Access Compliance Report

Public Rights-of-Way

(Curb Ramps)

Intersection ID: 45177	Main Street: ELDON_DR	Cross Street: GARLAND_CT	Location: SW
ADA ID: 501BE9E61FB1	Ramp Type: PerpDiag	Initial Pass/Fail: Fail	Overall Compliance: No
Severity Score: 12.5			
Codes/Mitigation Info/Possible Solution		Field Measurements/Component Compliance

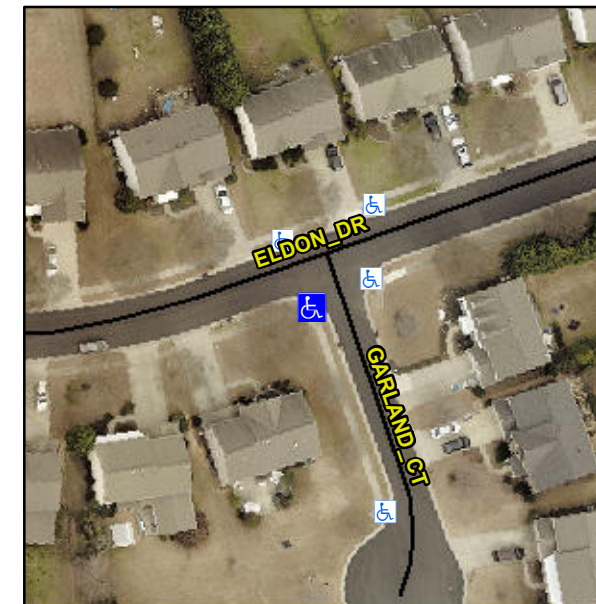
Not Found, R304.5.3

Compliance	Description	Data	Compliance	Description	Data
N/A	Ramp Length (in)	46.5	Yes	Ramp Slope (%)	6.8
Yes	Ramp Width (in)	59.0	No	Ramp XSlope (%)	5.3
N/A	Flare Type LT	N/A	N/A	Flare Type RT	N/A
N/A	Flare Slope LT (%)	N/A	N/A	Flare Slope RT (%)	N/A
N/A	Flare Traversable LT?	N/A	N/A	Flare Traversable RT?	N/A
N/A	Landing Length (in)	N/A	N/A	DWS Provided?	N/A
N/A	Landing Width (in)	N/A	N/A	DWS Contrast?	N/A
N/A	Landing Slope (%)	N/A	N/A	DWS Length (in)	N/A
N/A	Landing X Slope (%)	N/A	N/A	DWS Full Width?	N/A
N/A	Landing Curb? (Y/N)	N/A	N/A	DWS Offset (in)	N/A
N/A	Shared Landing?	N/A			
N/A	Gutter Ponding?	N/A	N/A	Gutter Slope (%)	N/A
N/A	Gutter Lip Ht (in)	N/A	N/A	Gutter X Slope (%)	N/A
N/A	Painted X Walk1?	No	N/A	Painted X Walk2?	No
	X Walk 1 Direction	To E		X Walk 2 Direction	To N
N/A	X Walk 1 Width (in)	N/A	N/A	X Walk 2 Width (in)	N/A
	X Walk 1 Slope (%)	4.2		X Walk 2 Slope (%)	0.5
	X Walk 1 X Slope (%)	2.3		X Walk 2 X Slope (%)	3.6

Remove & Replace Curb Ramp With Two New Directional Ramps or Equivalent.
